Weir Phillips Heritage and Planning

RE: Marist Catholic College North Shore (SSD-10473). Response to Submissions and peer review. NSW Government, Department Planning, Industry and Environment (DPIE)

APPENDIX A: SUMMARY TABLE Marist Catholic College North Shore (SSD-10473). Response to Submissions.

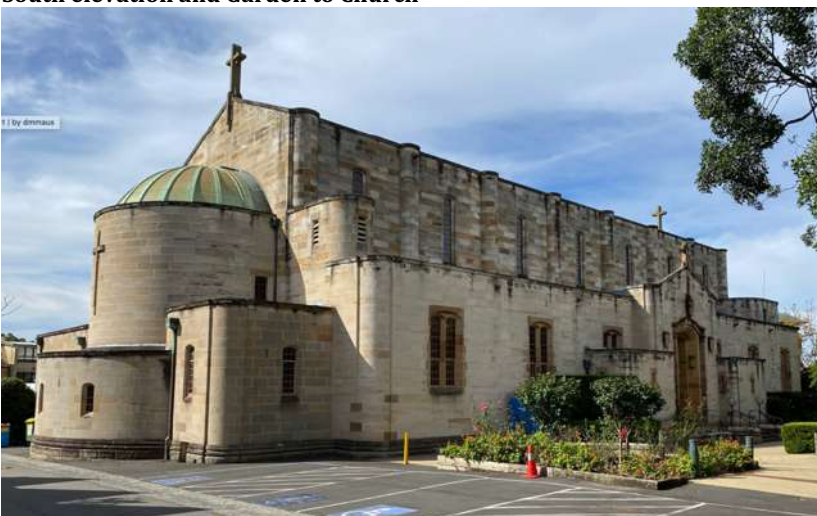
5.0	DPIE Comment
	<i>a detailed description of St Mary's Church and Presbytery and St Mary's Catholic Primary School is required. As work is being proposed to these items, a photographic and written description of each building, including identification of its architectural character, any notable features and the condition and integrity of the building is required. For example: in the case of the proposed changes to the confessionals inside St Mary's Church, internal and external images plus a detailed description would be required to demonstrate an understanding of the fabric being affected. The HIS should be amended to include this information.</i>
	HERITAGE RESPONSE- St. Mary's Catholic Church
	<p>St Mary's Catholic Church - History</p> <p>The Church was established in 1856, by Father Peter Powell, the first Parish Priest assigned to the area. It was accommodated within a tent on the space fronting Miller Street.</p> <p>A 40 ft x 25 ft timber Church, with three rows of seats soon replaced the tent. The Church is understood to have been a timber slab structure with raw tree trunks for posts, papered walls and reeds and bracken on the earth floor. The site included pasture and forage for feeding the 'Parish horse' which carried the Priest around his circuit which extended to the Hawkesbury River including crossing the Spit.</p> <p>In 1867, the second Parish Priest, Dean John Kenny arrived and set about providing a new permanent Church. Plans were made to build an 'Early English' style freestone church with Gothic detailing and a foundation stone was laid in June 1867. It was intended that ultimately transcripts</p>

<p>St. Mary's Church - Condition/ Integrity The Church is highly intact and is well maintained. It presents as having high integrity although the following intrusive elements are noted:</p> <ul style="list-style-type: none">• Pebblecrete paths in the southern garden.• Some new and replacement external balustrades.• Frameless glass hinged entry door fitted to the principal eastern elevation.
	 <p>Site of proposed internal works to the Church, outlined in red.</p>  <p>Detail of confessional doors and surrounding brickwork to be removed.</p>

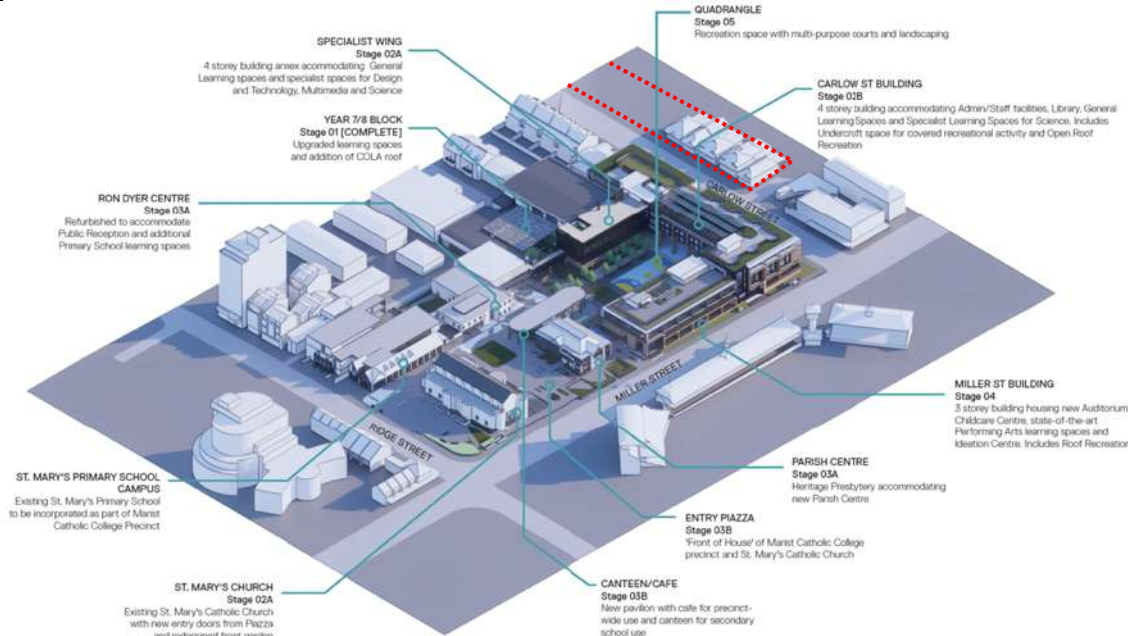
8.0	DPIE Comment
	<i>no reference is made to CA18 – Holterman Estate D. The HIS should be amended to add a description of the relevant portion of this HCA, a statement of significance, if available, and discussion of potential impacts from the proposal on the HCA. This is required to demonstrate that all heritage aspects of the site have been appropriately considered to ensure that the conclusions are soundly based.</i>
	HERITAGE RESPONSE - Holtermann Estate D Conservation Area

The Holtermann Estate D Conservation Area is set to both sides of the southern end of West Street and is defined by Falcon Street and Ridge Street. The landform is generally level and the urban form is determined by a strongly defined grid pattern of wide streets and narrow rear lanes.

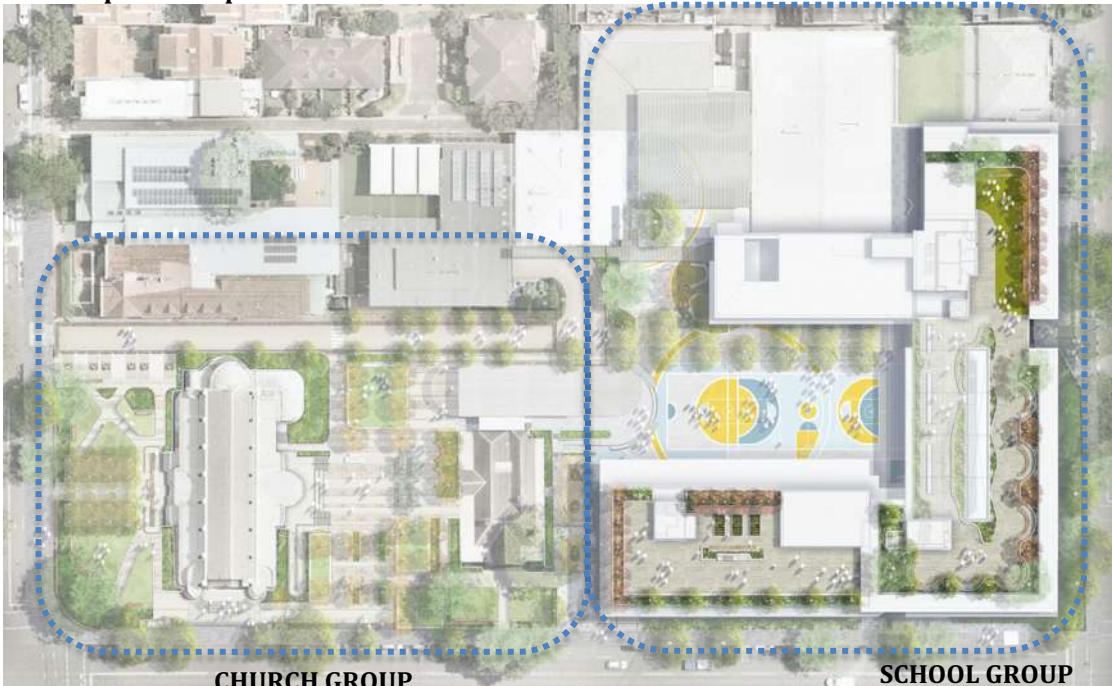
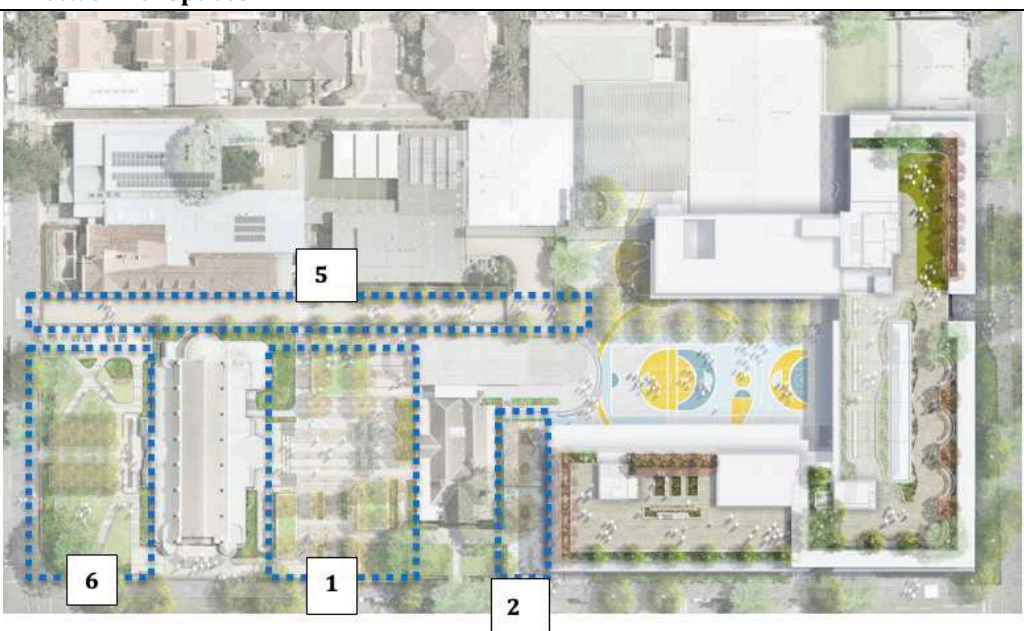
10.0	DPIE Comment
	<i>the setting and curtilage of the church group is not identified or described in the HIS, nor is there adequate analysis of the proposed impact of landscaping on the setting and relationships of the group. This is required to be addressed. More detail of the proposed cafe /canteen building is required to understand any potential heritage impacts on the appreciation of the Presbytery and setting of the church group.</i>
	HERITAGE RESPONSE
	<p>The Church group is defined as:</p> <ol style="list-style-type: none"> 1. St Mary's Church, 2. St Mary's Catholic Primary School and 3. St Mary's Presbytery. <p>Setting The church group is located in the vicinity of each other in the open setting of a large asphalt carpark which is intermittently planted with trees between the parking bays. The carpark extends between the north elevation of the Church and the presbytery to the north and the driveway between western elevation of the Church and the St. Mary's Primary's Primary School, and extends up to the Presbytery. The Church has additional curtilage to the south within the paved and landscape southern Garden which extends between Miller Street and Ridge Street.</p>  <p>LEGEND</p> <ul style="list-style-type: none"> Existing Hard Surface Existing Soft Surface <p>From Landscape Design Report - Oculus</p> <p>Existing Landscape The existing site consists of a high proportion of hard surfaces directly adjacent to and between the buildings of the Church group. The main soft surfaces and gardens to the buildings are confined to the front of the Primary School and Presbytery and to the southern Garden of the Church.</p> <p>The setting of the Church Group and College campus generally is dominated by hard paved surfaces including the existing at-grade car park, courtyards and main play space in the north part of the site. The existing site comprises:</p>

<p>10, 975 m2 Hard Surfaces (79%) 2, 993 m2 Soft Surfaces (21%)</p>
	<p>Proposed Landscape</p>
	<p>Landscape Masterplan – Oculus</p>  <p style="text-align: center;">CHURCH GROUP SCHOOL GROUP</p>
	<p>Church Precinct The Church Precinct is centred around the St Mary’s Church, St. Mary’s Primary School and Presbytery buildings and includes the following spaces:</p> <ul style="list-style-type: none"> • the new public piazza space; • the upgraded garden on the south side of the Church; • the upgraded garden in front of the Presbytery on Miller Street; and • the shared way forming part of the main north-south axis and the interface with the primary school and Ron Dyer Centre.
	<p>A network of Spaces</p>

<p>1. Public Piazza</p> <p>The public Piazza removes the asphalt carpark and replaces it with a pedestrian paved and landscaped area. The piazza increases and improves the visual curtilage of the church which enhances the setting and understanding of the church within the Church Precinct. The piazza connects the three buildings within the Church precinct through a unifying landscape/ pedestrian element. No significant heritage fabric is removed in the construction of the piazza.</p> <p>The Piazza works in tandem with the proposed modification of the confessionals as the new entry porticos to the northern elevation of the Church. The proposed porticos open out onto a granite paved terrace which overlooks and provides compliant access to the piazza.</p> <p>The terrace, stair and access ramp down to the piazza does not remove any heritage fabric of the church, the works are set at a low height are minor in scale in comparison to the church and are visually recessive to the significance of the Church. The ramp will be set within a landscaped garden to reduce the visual impact on the Church from Miller Street.</p> <p>The Piazza also:</p> <ul style="list-style-type: none"> • Creates a tranquil extension to the church • Enhances the setting and connectivity of the existing heritage buildings • Provides a welcoming and embracing public entrance to the precinct • Open to and welcomes interface with Miller Street • Creates an open congregation area for the parish, students, staff, visitors and the greater community • Creates a flexible use space to accommodate both every day uses and church / community events • Mediates level changes between the existing church to the south and the Presbytery to the north • Creates a landscape space with clear wayfinding to connect pedestrians from Miller Street to the main north-south axis and the broader extents of precinct
